**CITY OF AVON LAKE  
PLANNING COMMISSION  
150 Avon Belden Road  
Avon Lake, Ohio 44012  
(440) 930-4110**

**AGENDA  
Tuesday, August 5, 2025  
7:00 PM  
City Council Chambers**

**Case No. CPC-25-9**, Pulte Homes of Ohio, LLC, Major Subdivision Preliminary Plat Approval for Harbor Crest Townhome Subdivision, located in the southeast corner of Walker Road and Avon-Belden Road (SR 83).

**Case No. CPC-25-11**, Ford Motor Company, Ohio Assembly Plant, Site Plan Approval for the Construction of a New Vehicle Test Track and Installation of a New Stormwater Retention Basin.

Figure 1: Excerpt Entry Original Layout Drawing

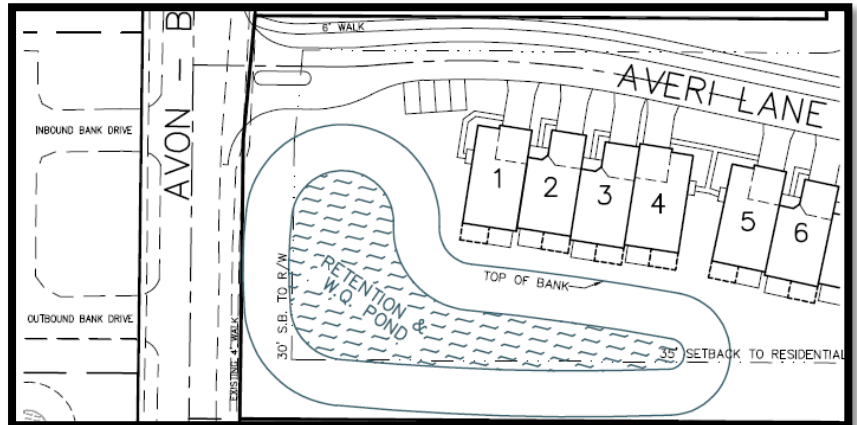
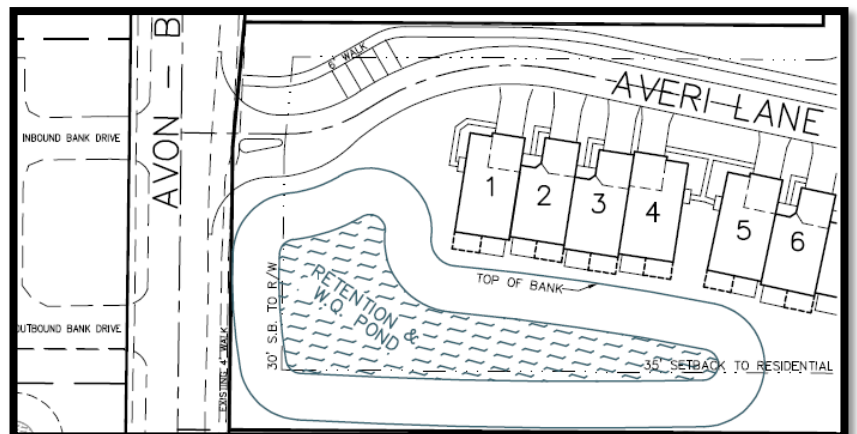
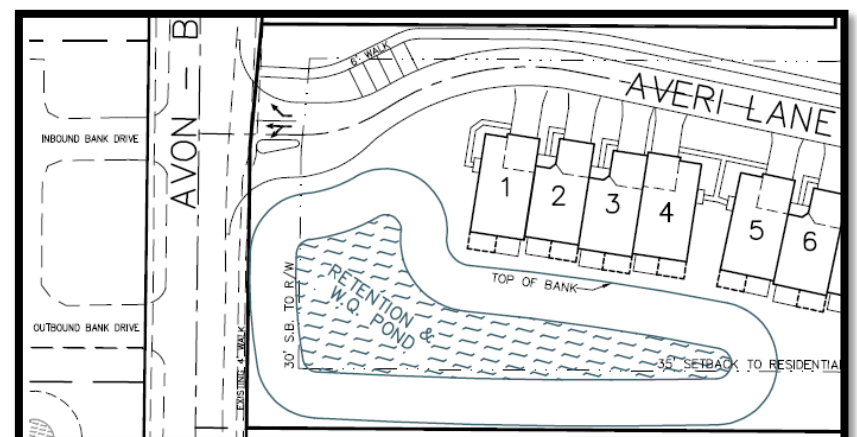
Fire Chief Betsa expressed concerns regarding the proposed alignment of the subdivision's entrance with the Huntington Bank driveway across Avon Belden Road. He indicated a preference for the original offset design, citing potential traffic safety risks associated with aligning two driveways at an uncontrolled intersection. Chief Betsa noted that if the bank's traffic pattern were to change in the future, such as allowing two-way access, the alignment could lead to dangerous, conflicting turning movements. He also opposed the inclusion of a center island at the entrance, stating it could obstruct emergency vehicle access, particularly for units approaching from the north. Additionally, he raised operational concerns about the reduced setback between the retention basin and the rear of the northern units, warning that the narrower space could limit fire personnel access or hose deployment during an emergency.

Public Works Director Liskovec acknowledged the preference for aligning the driveway with the Huntington Bank entrance, as supported by the traffic study and past city practices. He noted that while the addition of a left-turn lane in Alternate "2" improves traffic flow, it offers limited vehicle storage—likely accommodating only two cars—which could result in queued vehicles blocking right-turn movements. Director Liskovec also expressed concern over the revised stormwater basin design, explaining that the narrower and shallower configuration, particularly along the eastern side, may pose long-term maintenance challenges due to increased sedimentation and vegetation growth. Although he did not express a strong preference between the alignment options, he emphasized the trade-offs involved, particularly for stormwater management, vehicle circulation, and emergency access.

Mayor Spaetzel highlighted that aligning the subdivision's entrance with the Huntington Bank driveway supports both the traffic study's recommendations and the city's broader plan for coordinated access. He explained that this strategy is based on established traffic planning principles, but recognized Chief Betsa's concerns about possible turning conflicts at an uncontrolled intersection. Citing issues observed with offset driveways elsewhere in the city, Mayor Spaetzel emphasized the importance of carefully considering the traffic engineer's findings alongside departmental input to find a balance between traffic flow and public safety.

Planning and Zoning Manager Austin Page expressed a preference for Entry Alt #2".

Figure 4: Excerpt Original Stub Layout

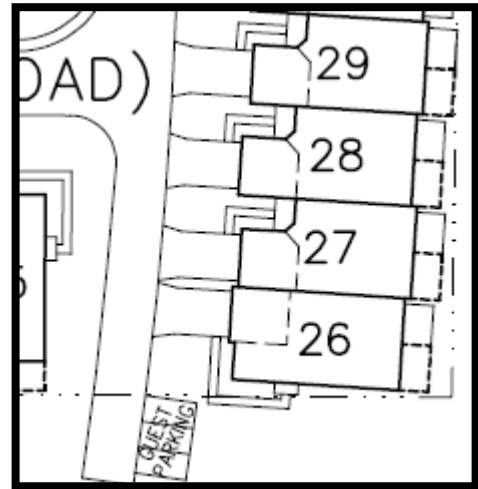
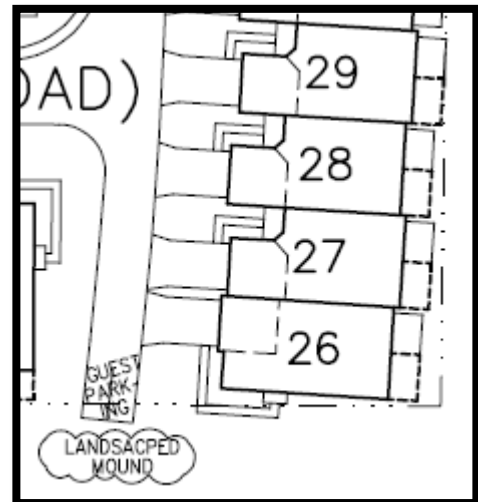
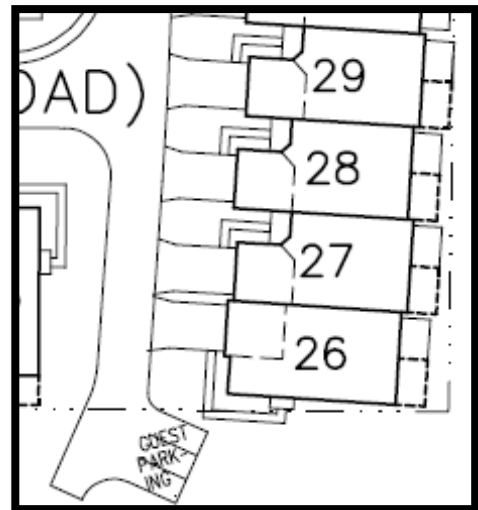
Chief Betsa supports maintaining the potential for future connectivity at the southeastern stub street, emphasizing its importance for emergency response access, even if the land nearby remains undeveloped for years. He recommends keeping the full 22-foot length of the stub to ensure safe passage for fire trucks and suggests adding a turnaround or widening the end to improve maneuverability and effectiveness during emergencies.

Director Liskovec supports keeping the stub street's connectivity potential, aligning with the city's broader planning. He recommends maintaining the 22-foot pavement, noting that an earlier plan to reduce it to 18 feet would not support vehicle circulation or access effectively. Director Liskovec warns that visual changes—like landscaped mounds or curves—could discourage future connections, but they do not legally prohibit them.

Mayor Spaetzel recognizes that some residents might oppose future connections but stresses that the Planning Commission must balance those concerns with the city's longstanding goal of fostering interconnectivity between developments. He points out that such connections have historically improved circulation and access, benefiting both routine traffic and emergency response.
